ANNEX 2: OCA COMMENTS ON BUILDING HEIGHT AND MASS AND VISUAL IMPACTS ON SENSE OF PLACE AND HERITAGE VALUES

Diagram 2a. Visual impact of Precinct 1 construction as per 2018 submission (VIA dated 2017) from black River at the point of Berkley Rd crossing. Source Annexure C9

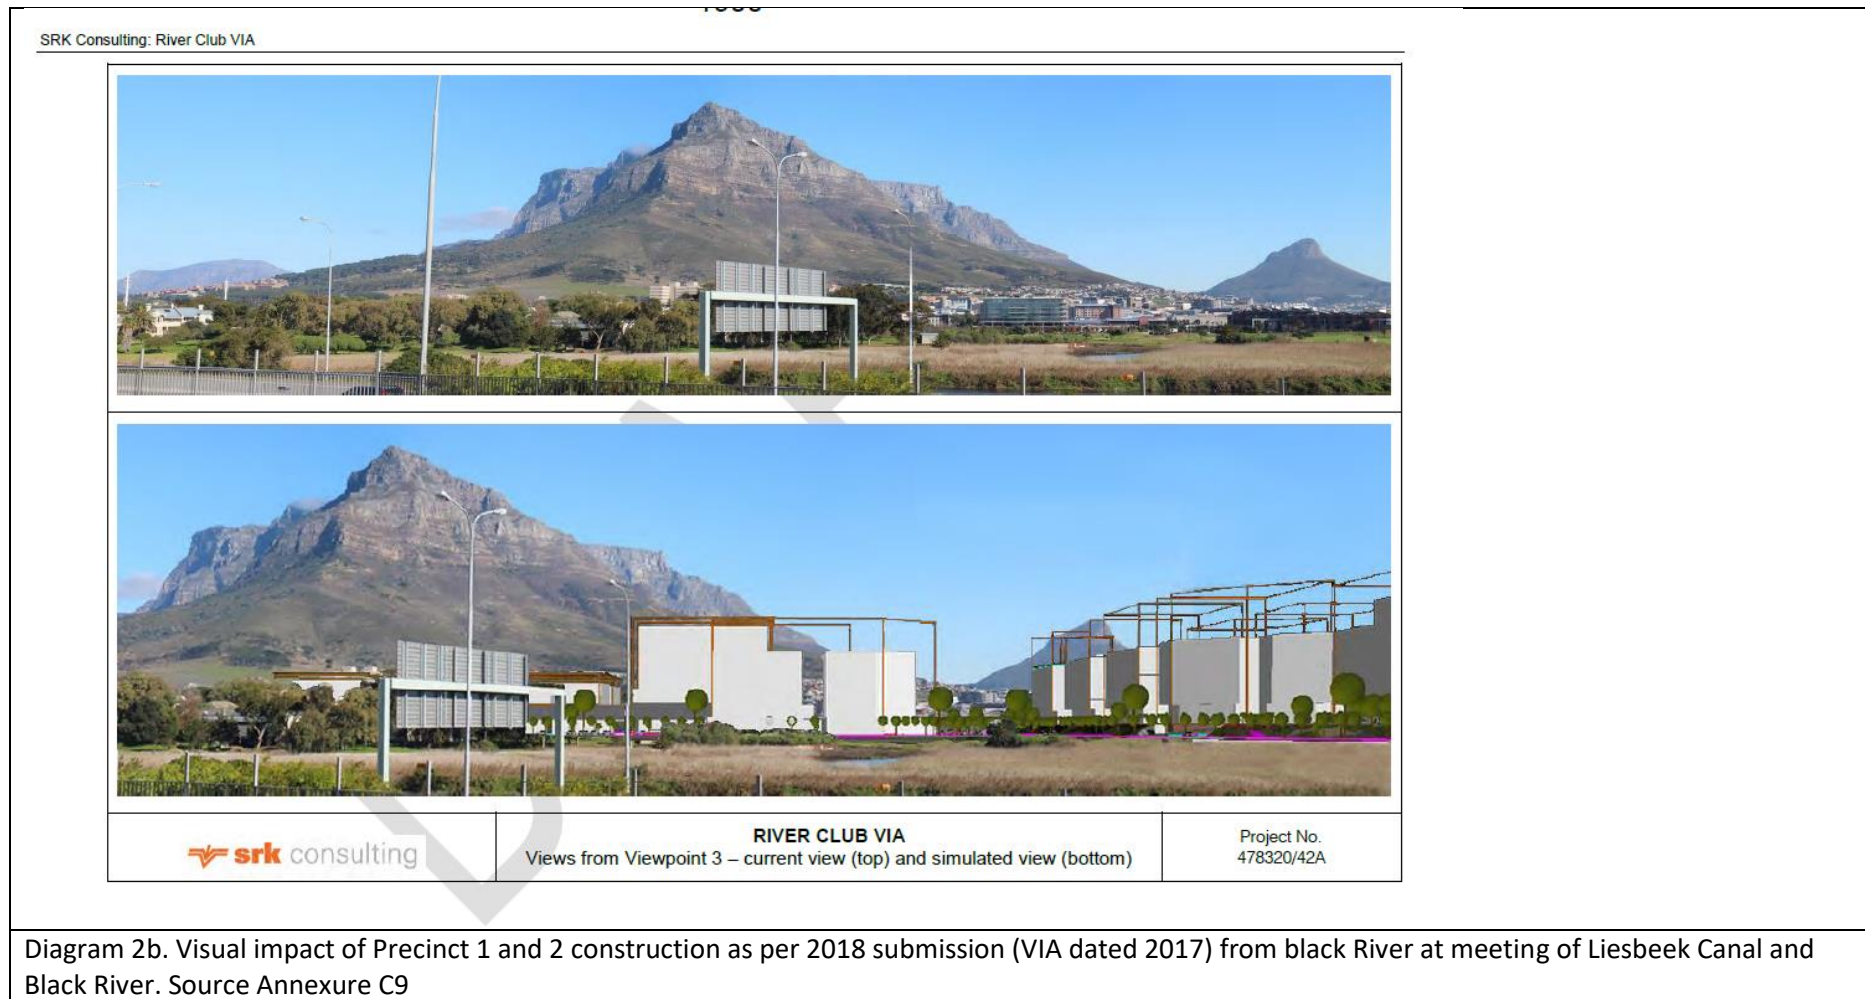
How might this look visually? The Visual Impact Assessment (Annexure C9) has not been updated since it was completed in 2017, so what that study presents are the visual impacts of the original design which has now changed. However, the buildings in the original design were 23m tall in the front and 41m behind (Diagram 2 taken from the BAR documents). As is clear from diagrams 2a and 2b below, this means that the visual representation from 2017 probably understates the likely impact since the building nearest the confluence is now 13m taller in front and 5 m taller behind.

How exactly are ceremonies, which have significant spiritual resonance, going to take place in the shadow of buildings 36 to 46m tall?
